Diablo Canyon Units 1 and 2

Response to NRC Request for Additional Information Regarding PG&E Letter DCL-11-072, "License Amendment Request 11-06, Revision to Technical Specification 3.3.5, 'Loss of Power (LOP) Diesel Generator (DG) Start Instrumentation" dated October 24, 2011

***PG&E Response to NRC Request for Additional Information for  
Diablo Canyon Power Plant Regarding Technical Specification 3.3.5***

**Attachment 2  
PG&E Drawing 441340**

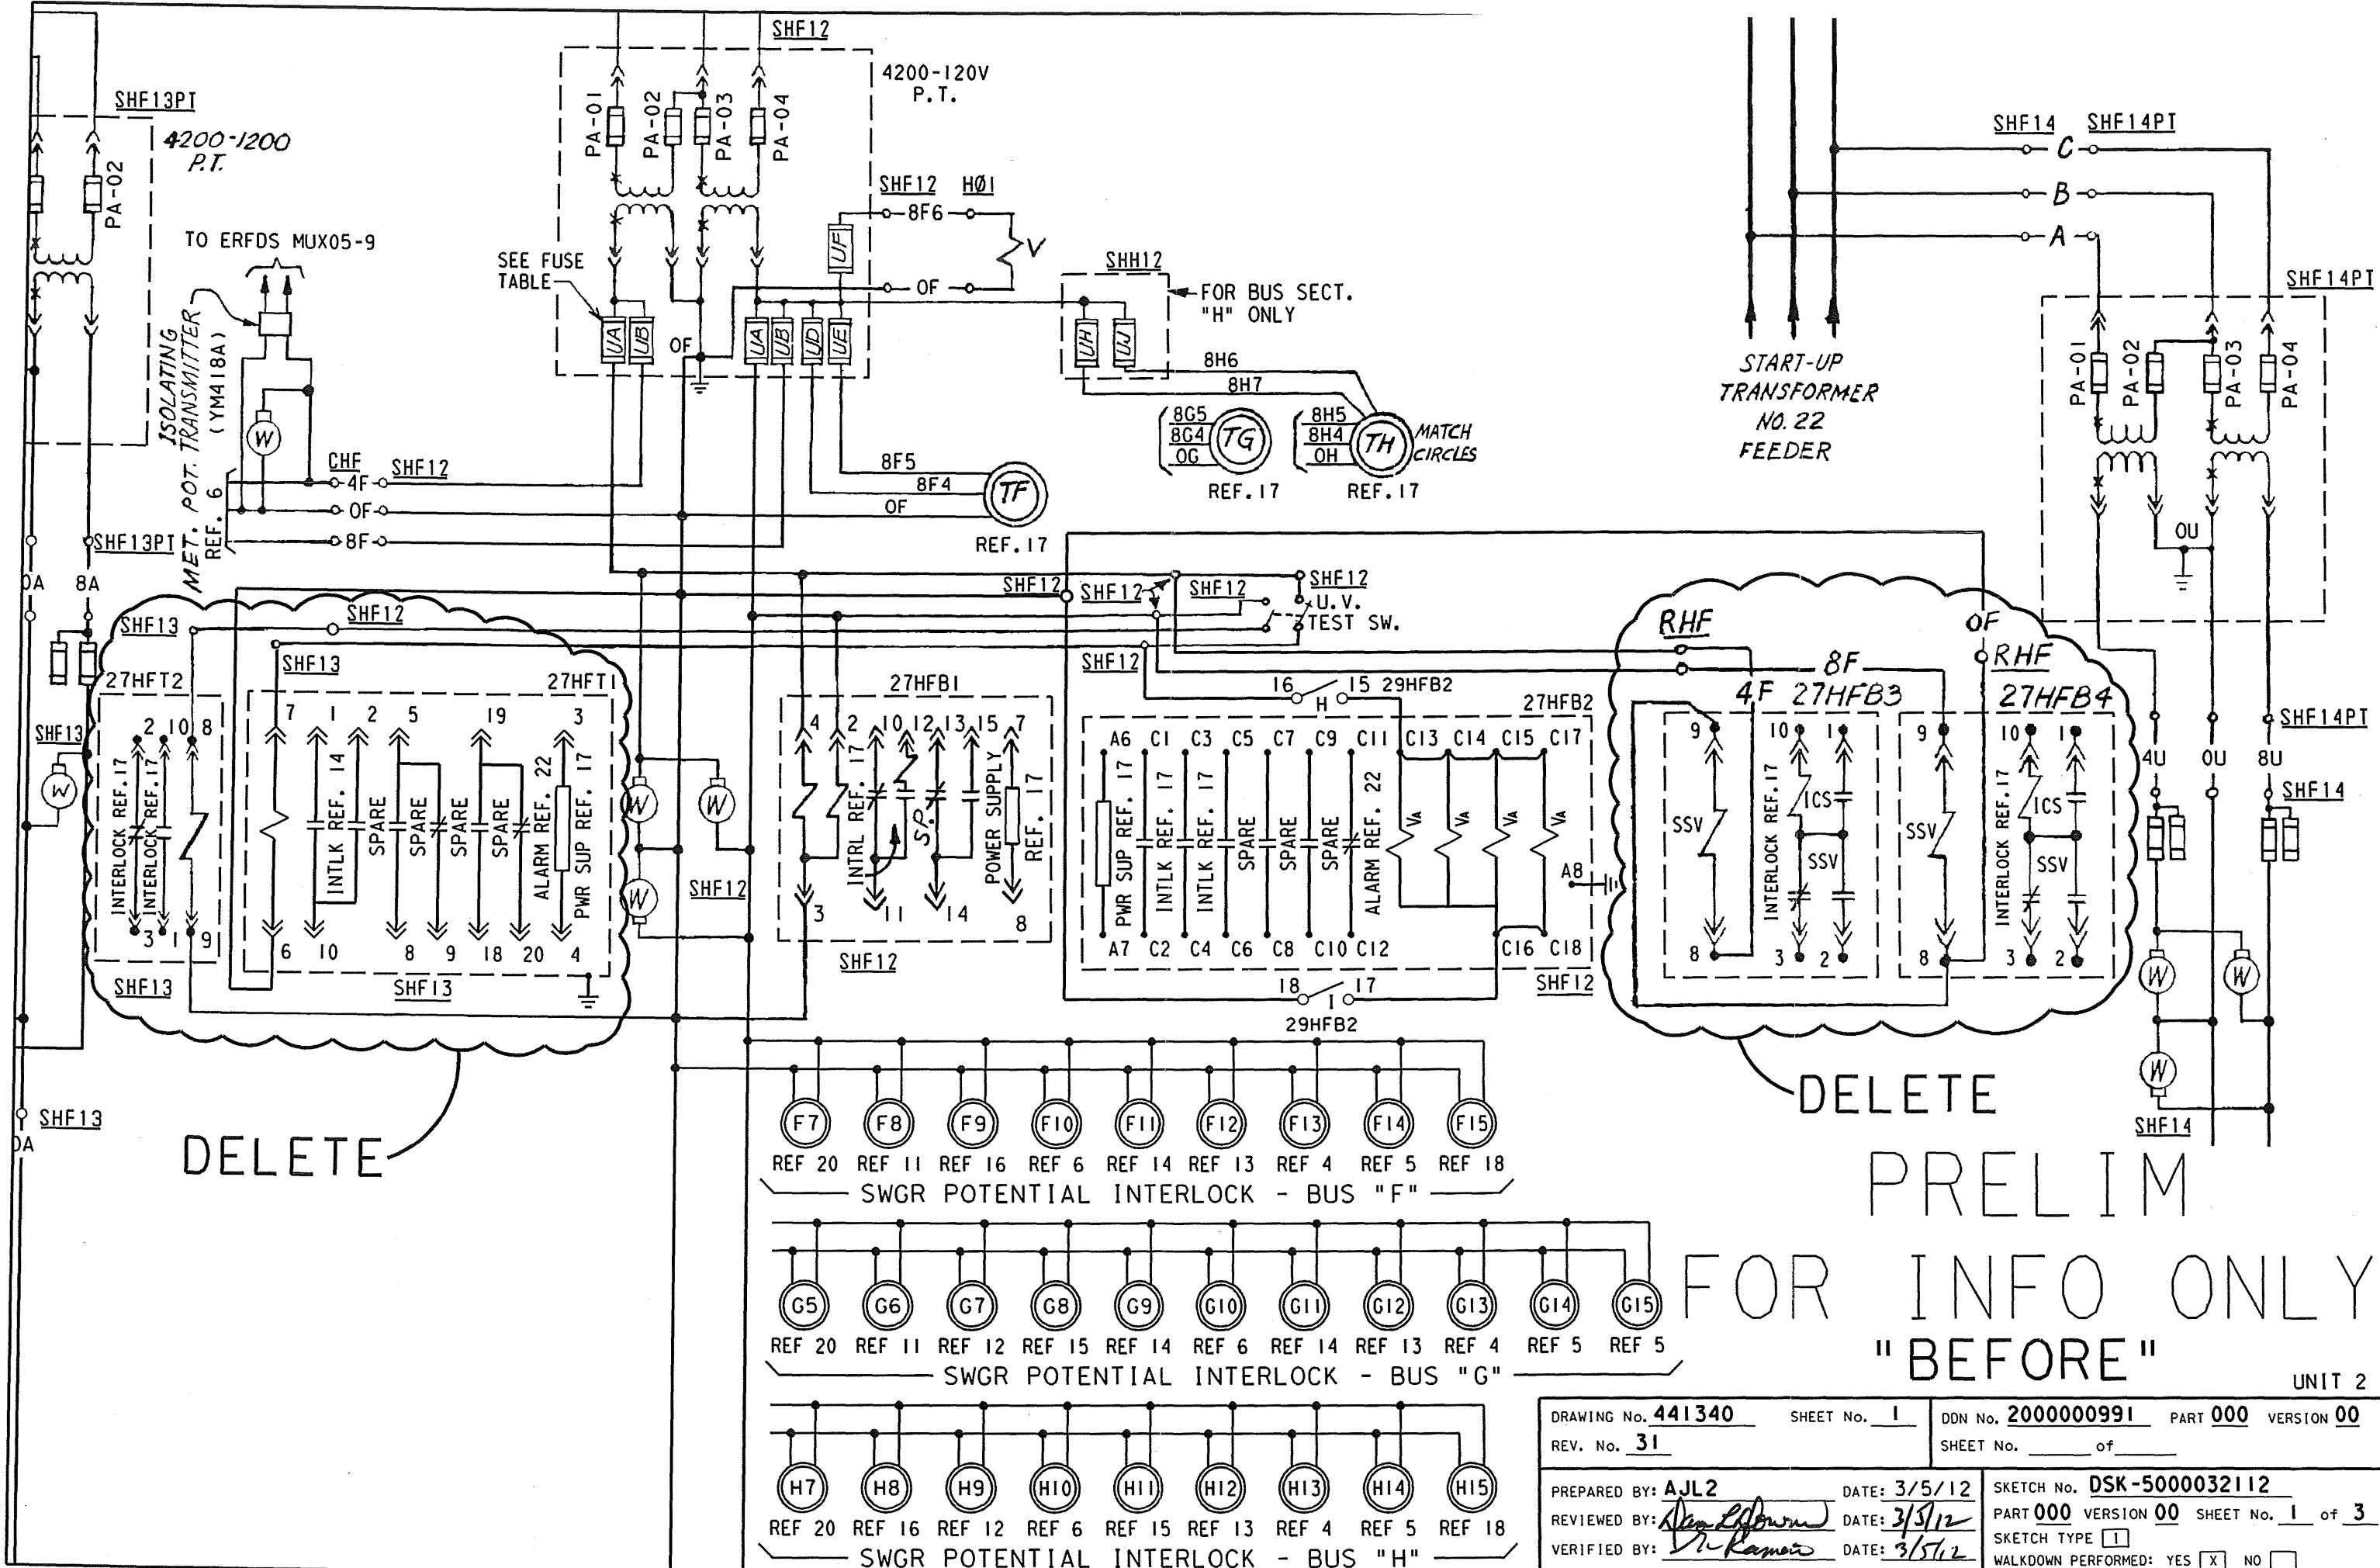
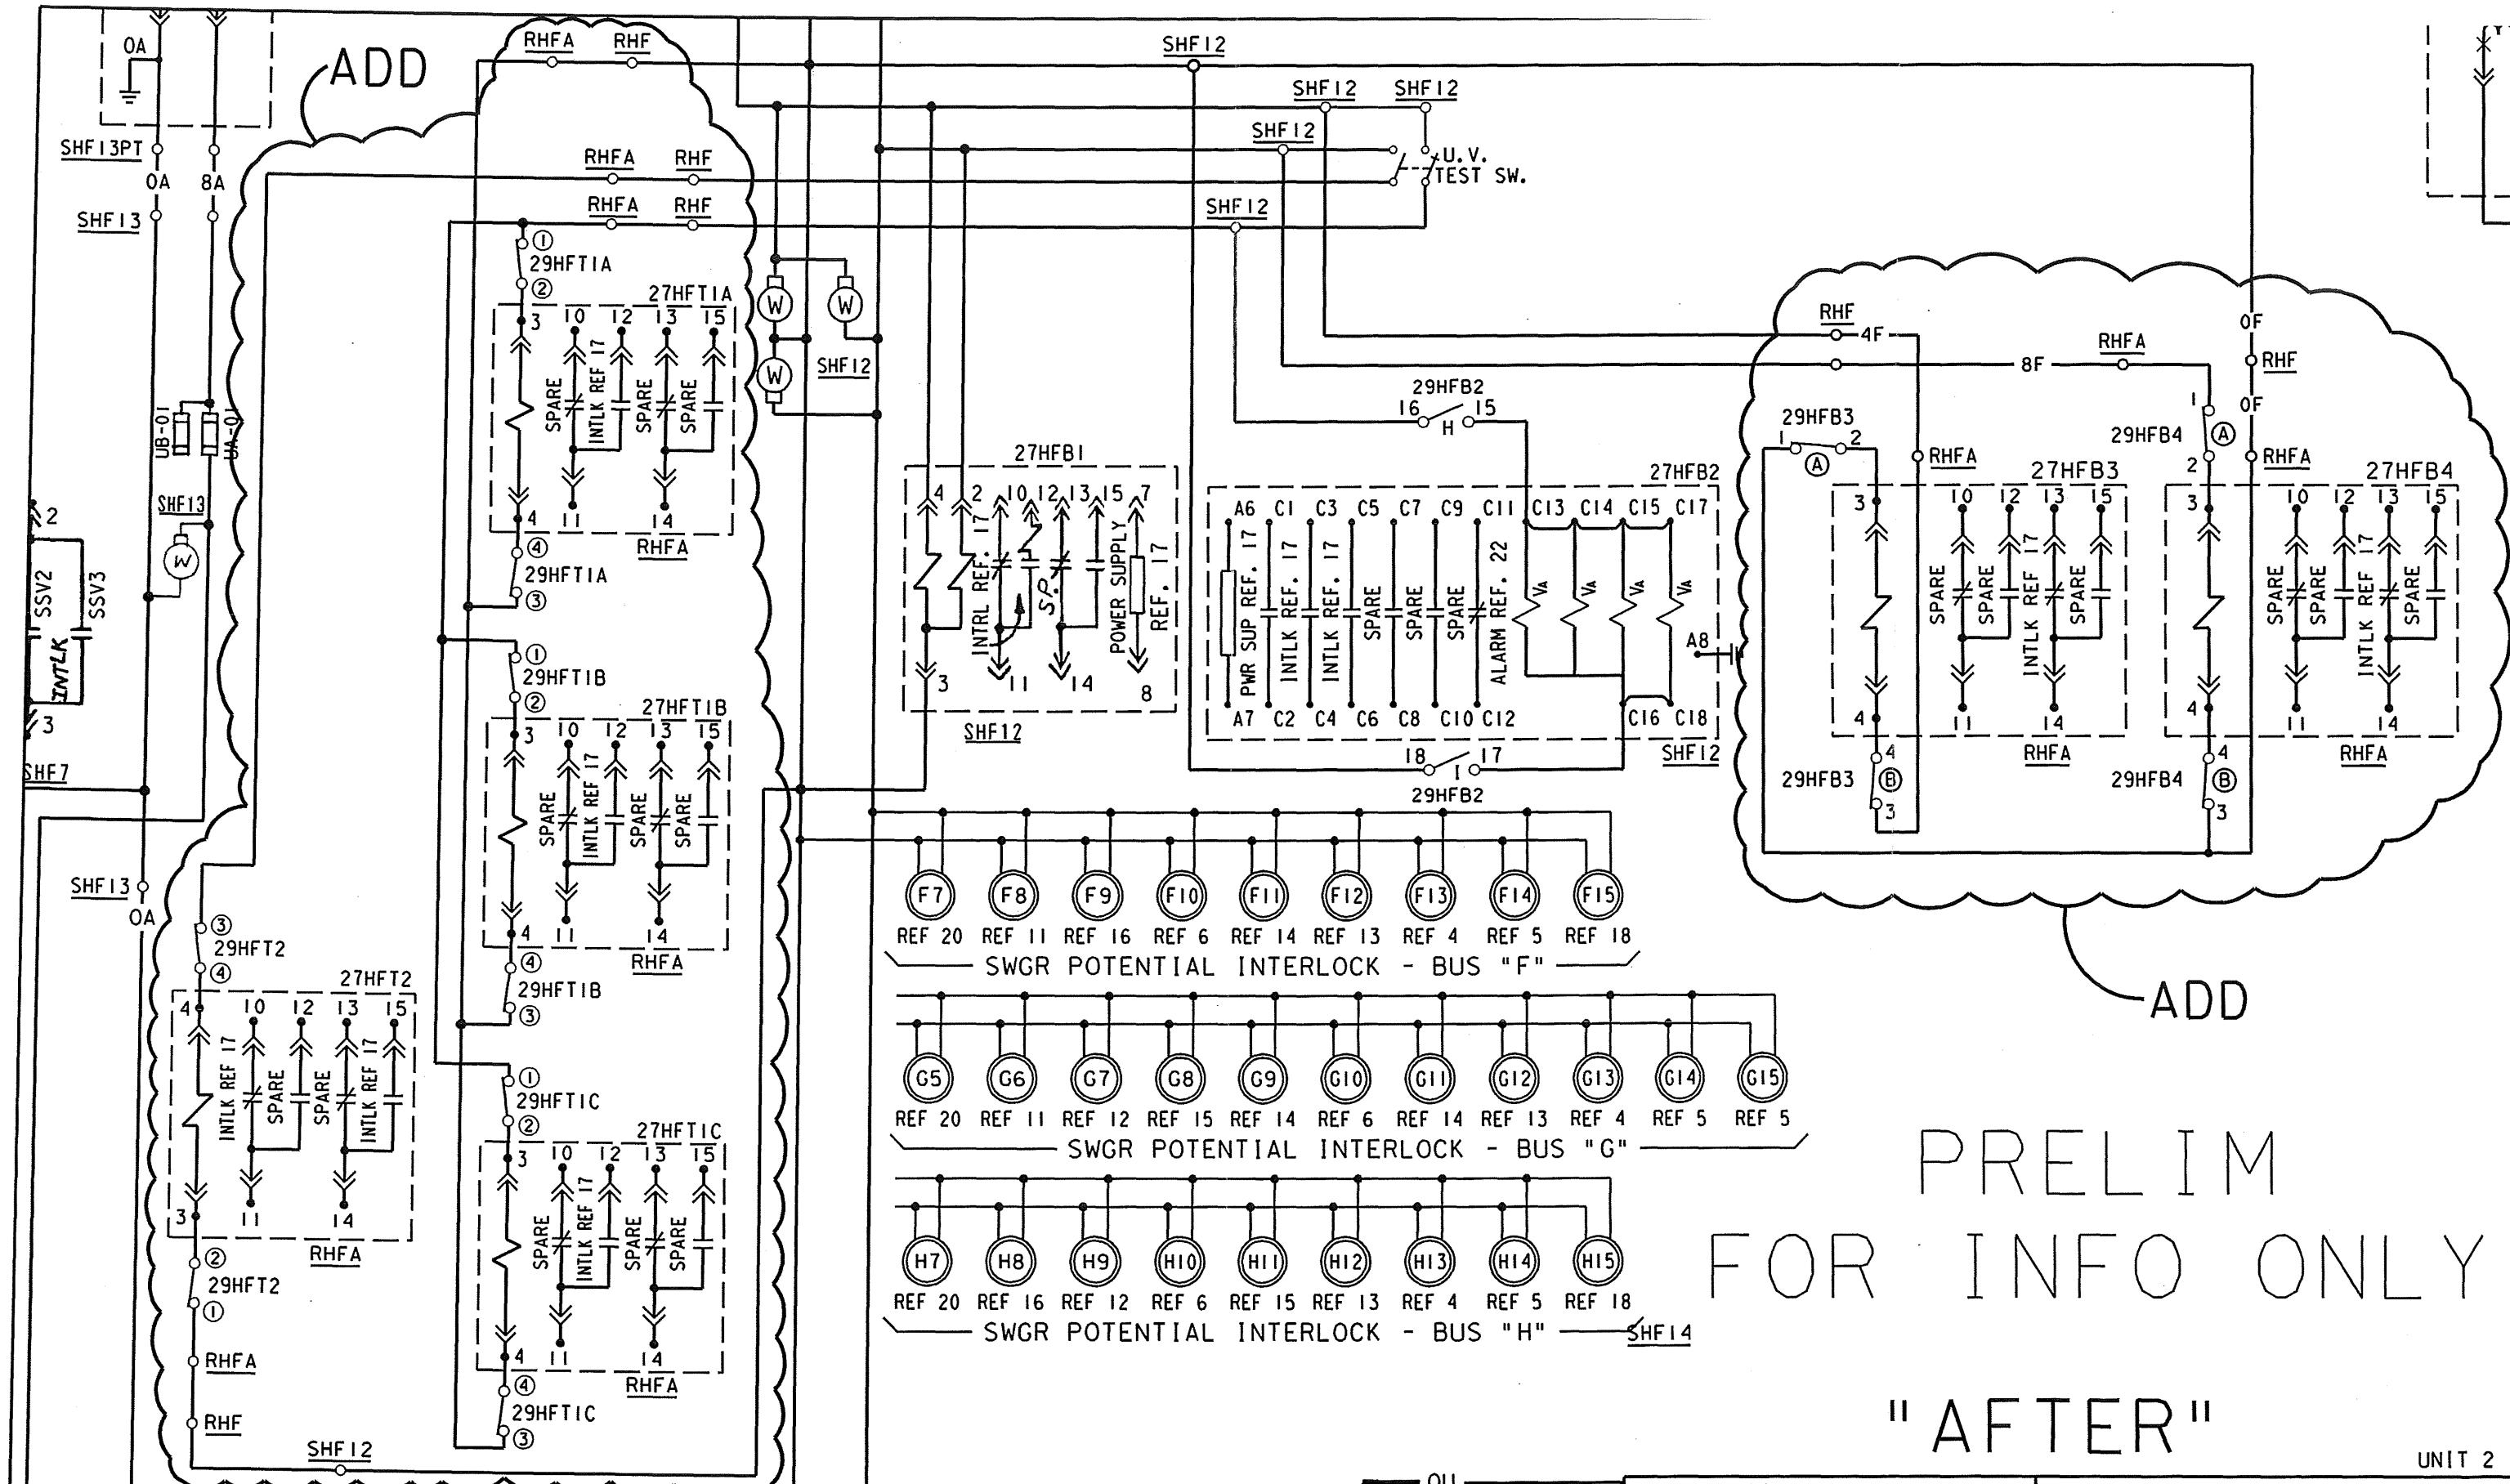
*Please provide diagrams indicating how the different devices described above are connected including the connection of the potential transformers and the relays, to enable the staff to understand the justifications requested above. Indicate what combination of relays are required to ensure that the required protective action is successfully achieved.*

Informational logic diagrams, schematics and connection diagrams are attached to this submittal as listed below. Drawings are stamped "PRELIMINARY FOR INFORMATION ONLY" as the design change to implement the new protective logic is still in the development phase. However the following is not expected to change: logic, coincidence, permissive design, and relay connection.
